Sandia National Laboratories

ASSESSMENT OF TEXAS UTILITIES RESPONSE TO USNRC RAI ON AMPACITY DERATING TEST AND ANALYSES

Technical Evaluation of TUE Response
to Ampacity Derating Questions
Raised August 30, 1994

A Letter Report to the USNRC

Figure 1: General geometry of the two-tray thermal model.

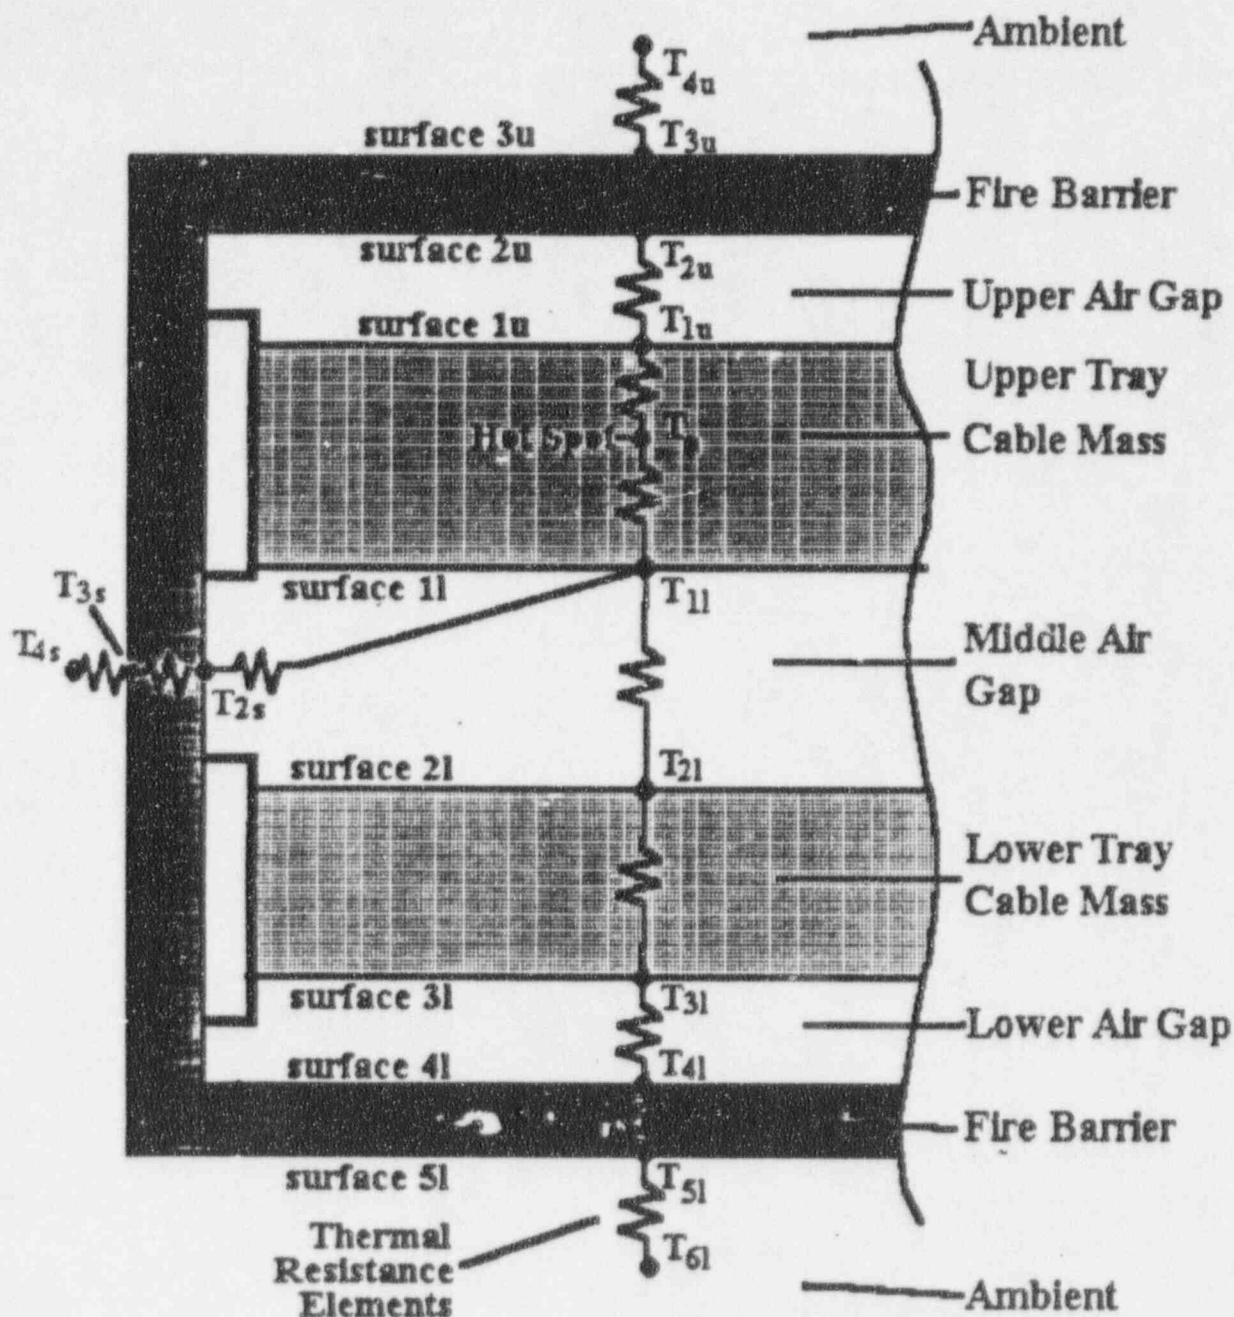
Due to the manner in which the TUE analysis was executed, it is recommended that it be given no credit as demonstrating that the TUE two-tray, single-box configuration is acceptable. While the TUE conclusion may, in fact, be correct for at least some configurations, this analysis was performed poorly and should not be credited as supporting TUE's conclusion. (Note that SNL has provided an alternate analysis

Figure 4: Effect of tray width on ampacity derating factors for a given tray-to-tray spacing.

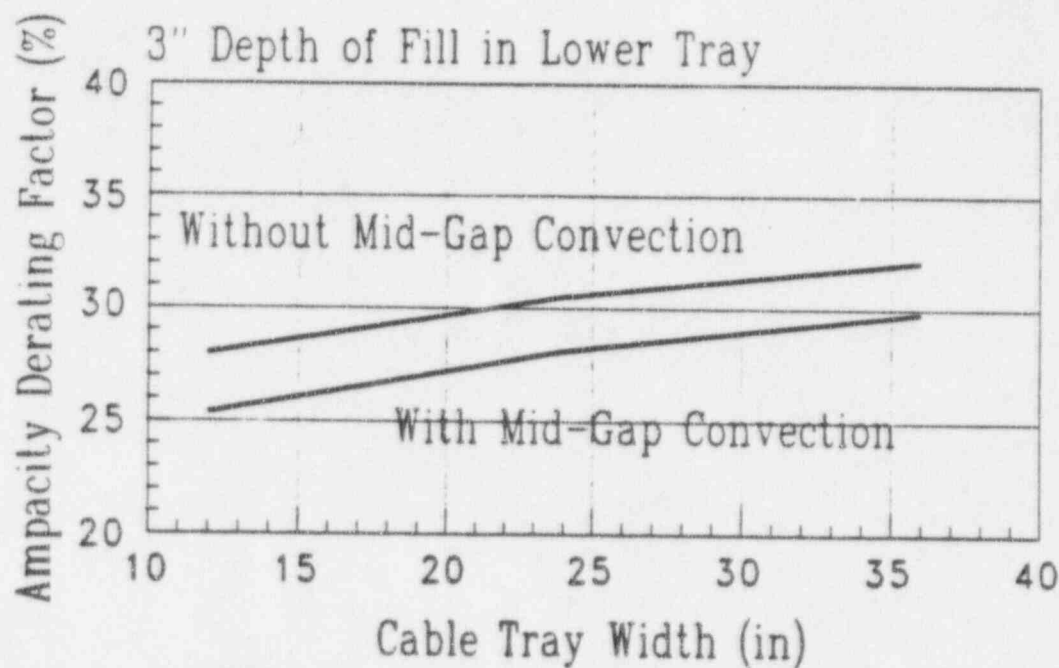
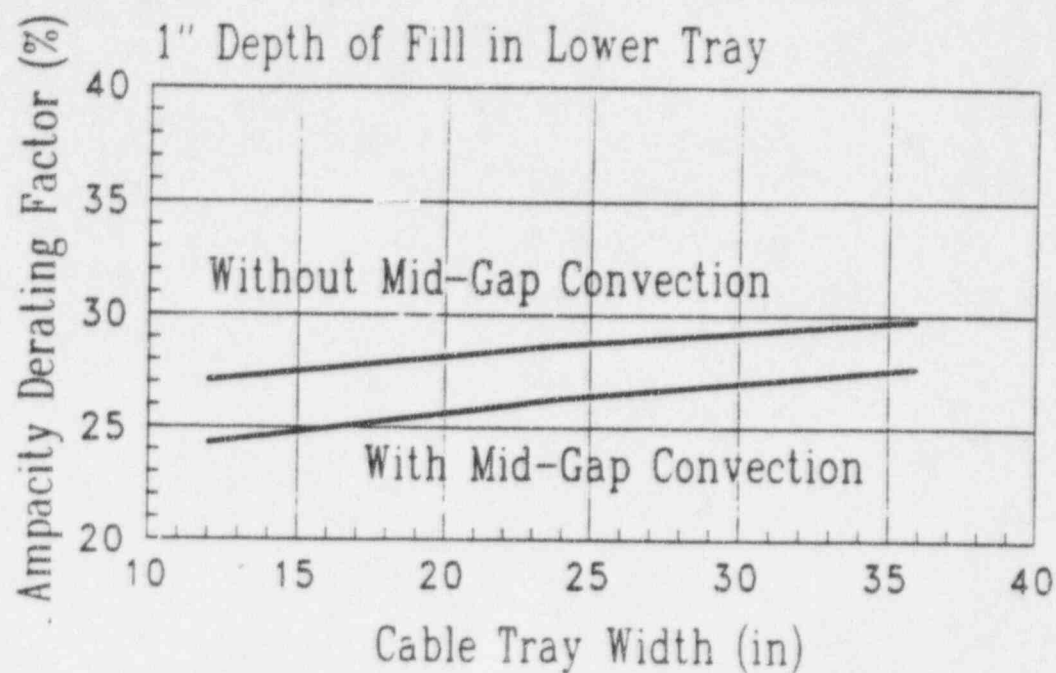
One of the factors not fully characterized for the TUE applications is the range of cable tray widths for the two-tray enclosures. Figure 4 illustrates the impact of this parameter on the ampacity derating factor for a fixed cable tray-to-cable tray separation distance (gap height). All of the simulations shown assume a 3" depth of fill in the upper tray, the approximate thickness of the cable mass in a standard test tray. These cases also assume a 9" tray-to-tray gap which is cited by TUE as the minimum tray separation distance. The results are illustrated for two depths of fill in the second lower tray, namely, 1" and 3". Note that as the cable tray width increases, the predicted derating factor also increases. This effect is due to the fact that as the tray becomes wider for a fixed gap height, the ratio of the gap height to tray width decreases. As illustrated in the analytical development above, the heat transfer through the side panels must be normalized by this ratio (see Equation 4, e.g.). Thus, the relative importance of the side panels is lowered as the tray width increases.

Figure 5: Effect of tray-to-tray separation distance on derating factor.

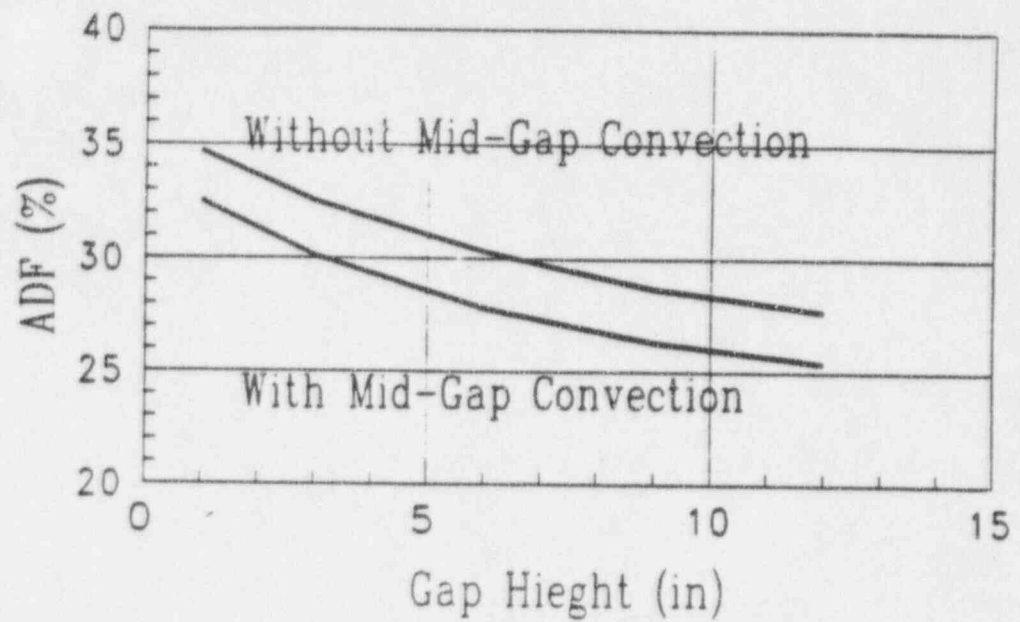
A similar impact is noted when changes in gap height are considered for a fixed tray width. Figure 5 illustrates this effect for a 24" wide tray with a 3" depth of fill in the upper tray and a 1" depth of fill in the lower tray. Note that as gap height decreases, the derating factor increases. The explanation is identical to that presented immediately above. In this plot there is, in fact, one case in which the gap width is sufficiently large that the predicted two-tray derating factor is lower than the nominal single tray derating factor predicted for this case (the 12" gap case where convection is included in the calculation). This is, in effect, what the TUE analysis predicted would occur for all cases. Clearly the SNL calculations do not agree with TUE's conclusion in this regards.

Figure 6: Effect of lower tray cable mass thickness on ampacity derating factor.

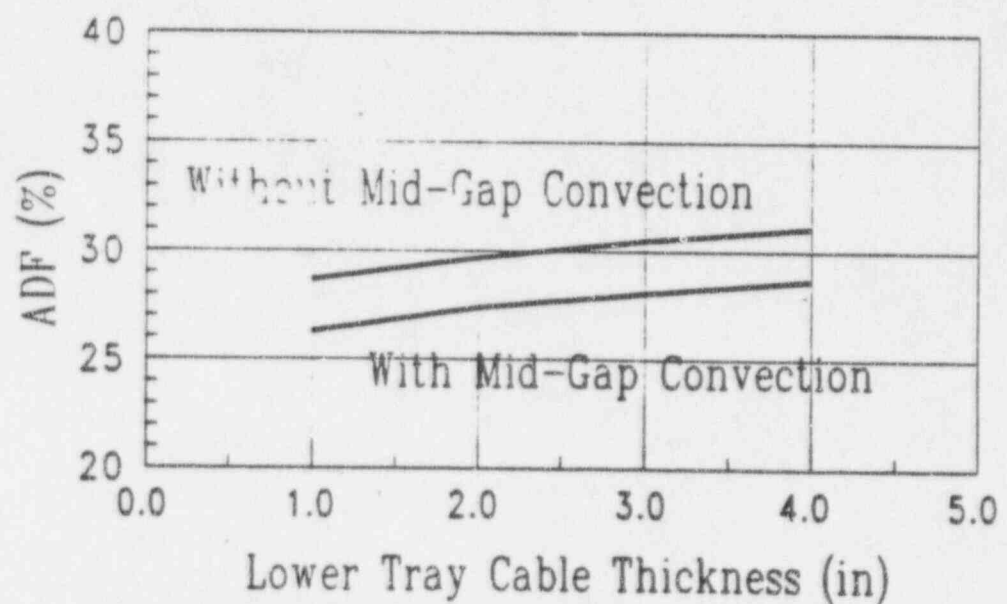
One final factor not characterized for the TUE applications is the thickness of the lower tray cable mass. As this mass increases in thickness, a greater insulating effect is realized, and hence, a greater ampacity derating impact would be expected. This is reflected in Figure 6 which illustrates the impact of the thickness of the lower cable tray cable mass on the resulting derating factor for a pair of 24" wide cable trays. For these cases it was assumed that the upper cable mass is 3" thick, and the tray-to-tray separation was 9".

Figure 1: Impact of conduit surface emissivity on current carrying capacity of cables housed in a 1" conduit. Values have been normalized to value with ($\epsilon=1.0$).

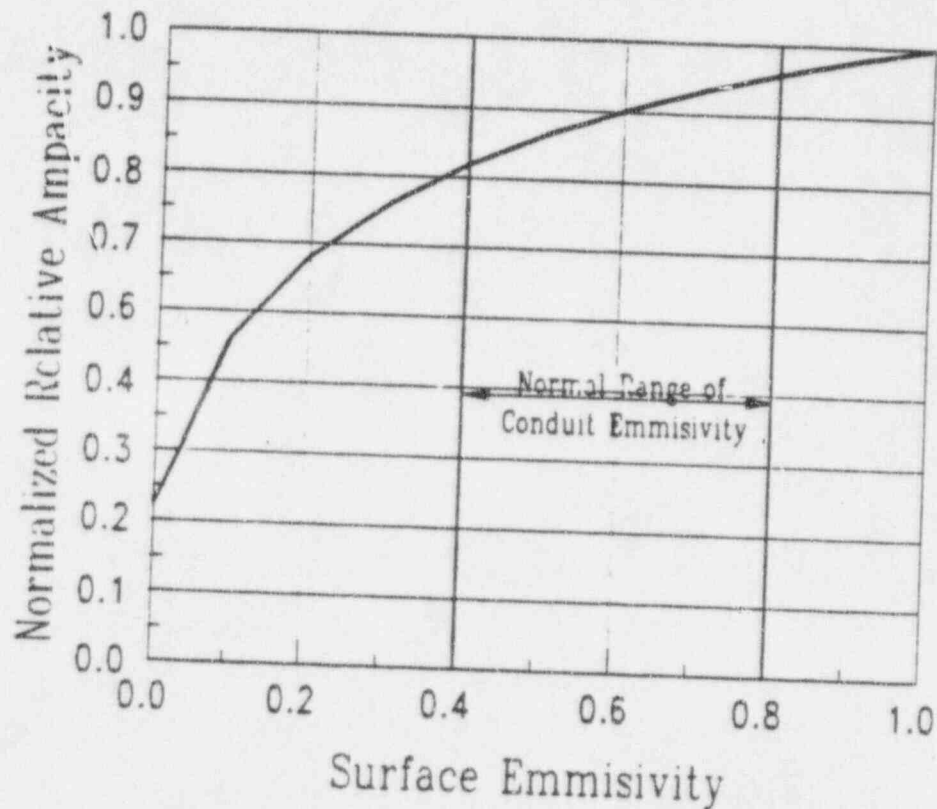
Using this analytical model, the impact of changing conduit surface emissivity on the ampacity of an unprotected conduit was assessed. The results are presented in Figure 1. These results assume a conduit diameter of 1", the same size as that used in the TVA tests on which the effective cable-to-conduit thermal resistance was estimated. Note that use of a small conduit for this calculation is also conservative because convective coefficients generally increase with conduit diameter for other factors

In reality, an emissivity value of 1.0 would never be achieved. In a meeting August 30, 1994, TUE stated that it had measured a range of conduits from its plant stocks and that the emissivity of these conduits varied between 0.4 and 0.8. These limits are considered typical of conduit behavior, and have been highlighted in Figure 1. Using these limits, the impact of realistic emissivity variations can also be estimated. Using the values from Figure 1 one can show that a cable housed in a conduit with an emissivity of 0.8, the upper end of the range, would be able to carry 119% of the ampacity limit for that same cable when housed in a conduit with an emissivity of 0.4, the lower end of the range.
